AGENDA PLANNING COMMISSION MEETING CITY OF SHOREVIEW

DATE: DECEMBER 3, 2013

File No: 2503-13-30

Applicant: Saint Marie, LLC Location: 181 Saint Marie

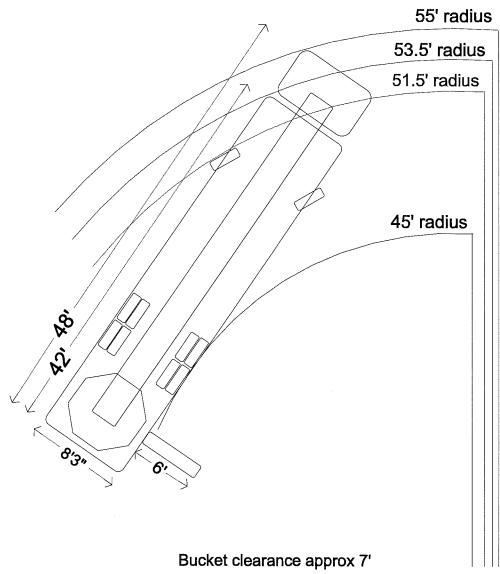
- > Verify location of Fire Department Connection
- > FDC is required within 150' of a Hydrant
- > Verify location of the sprinkler riser room
- > Fire Department Lock Box is required on building
- > Access concerns:
 - o Ensure both entrances to site can accommodate ladder truck
 - Ensure main building entrance can accommodate ladder truck. It would be nice not having to back a truck out.
 - o Ladder truck turn radius information attached
- ➤ Highly recommended that the sprinkler system be zoned by floor
